SUBJECT: Review Comments on the Crandon Mining Company Groundwater Flow Model,
Dated August 1996: Model Input - Unconsolidated Glacial Geology

Re: Verification of Model Input Data Representing Unconsolidated Glacial Deposits in the Crandon Mining Company's Ground-Water Flow Model.

Verification of Model Input Data Representing Unconsolidated Glacial Deposits in the Crandon Mining Company's Ground-Water Flow Model

Figure 16

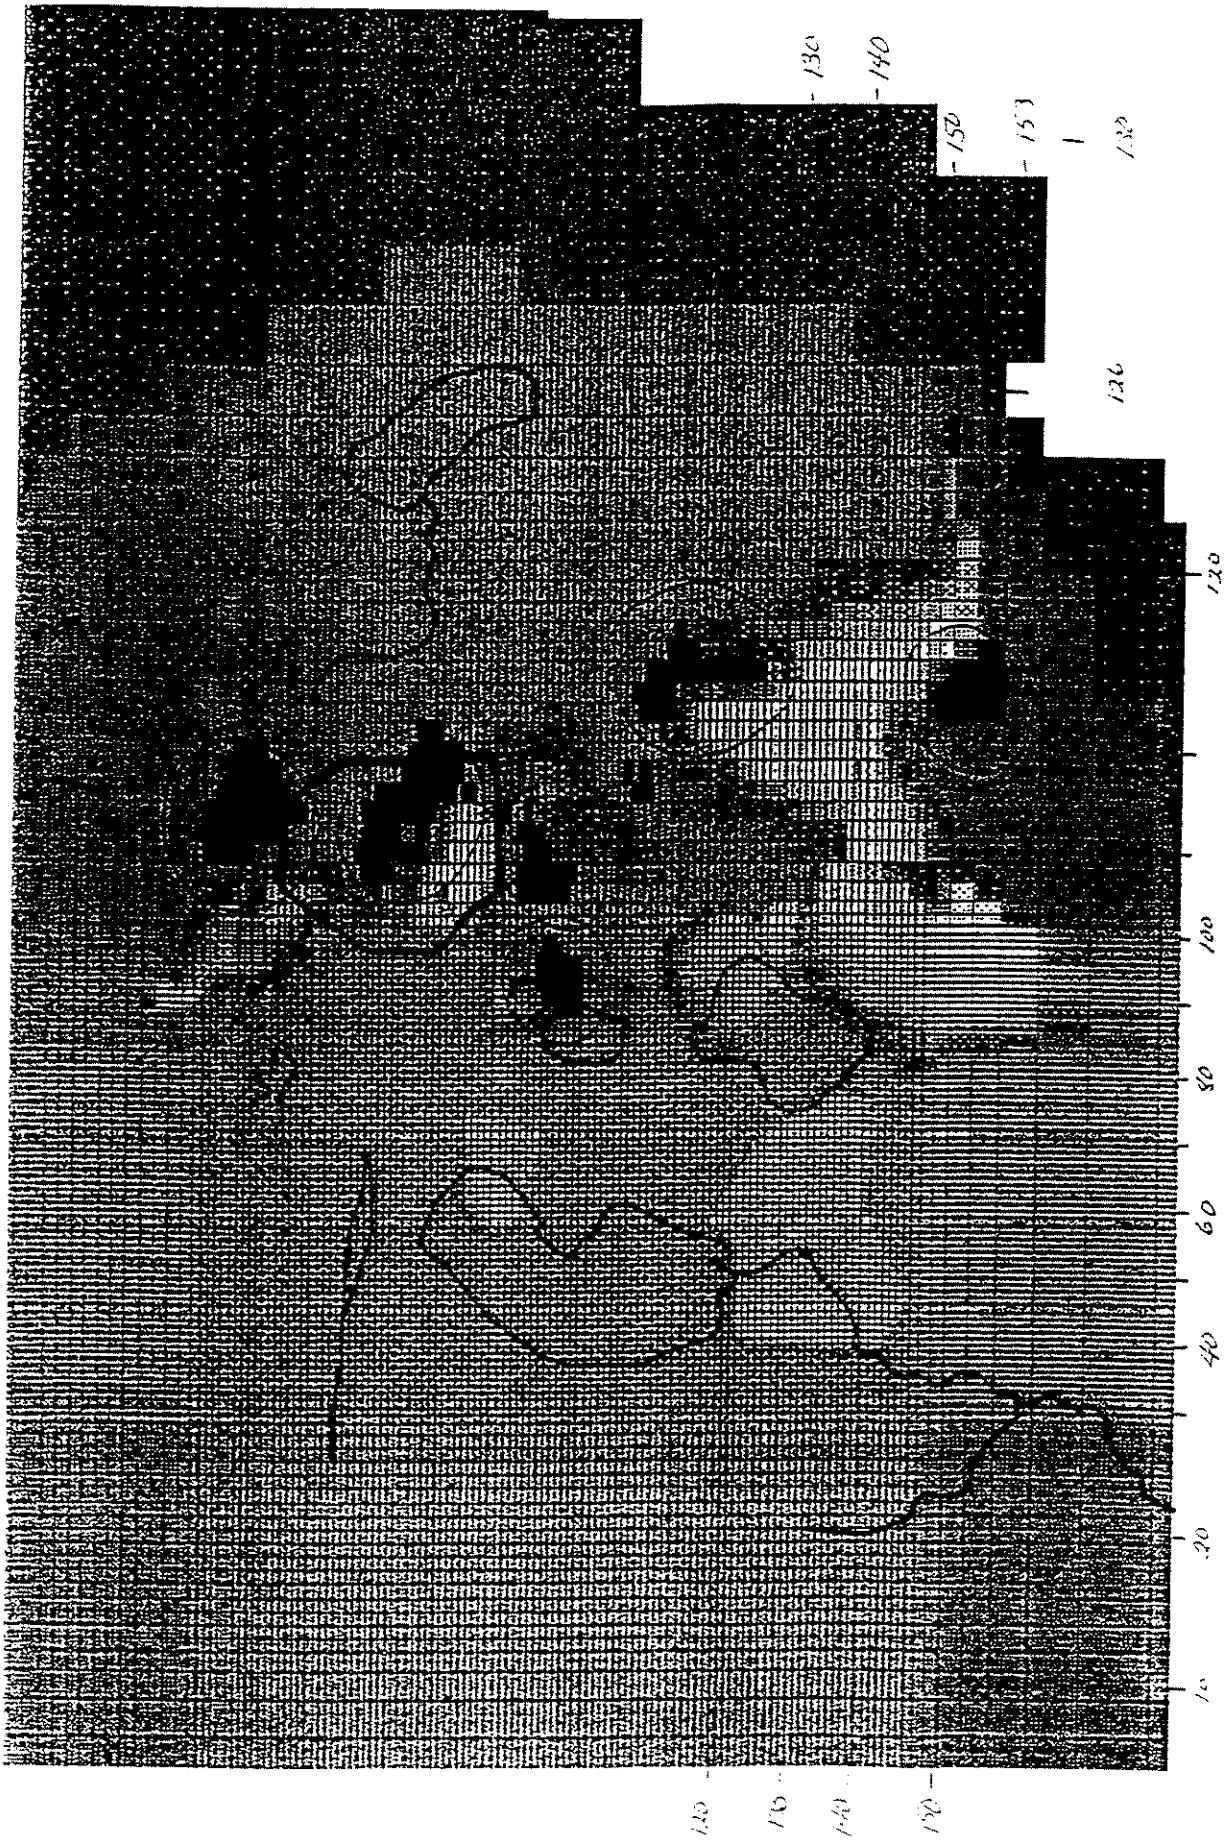
- Layer 4 includes some areas of Kh which are significantly higher or lower than expected for Early Wisconsin till (0.8 feet/day). Areas are found with Kh values as low as 0.071 feet/day, and as high as

43 feet/day. These areas are concentrated around the interior lakes and under the TMA (Figures 15 and 16). The input value for Layer 4 conductivity is significant because of its influence on the movement of water between the glacial sediments and the bedrock in the model.
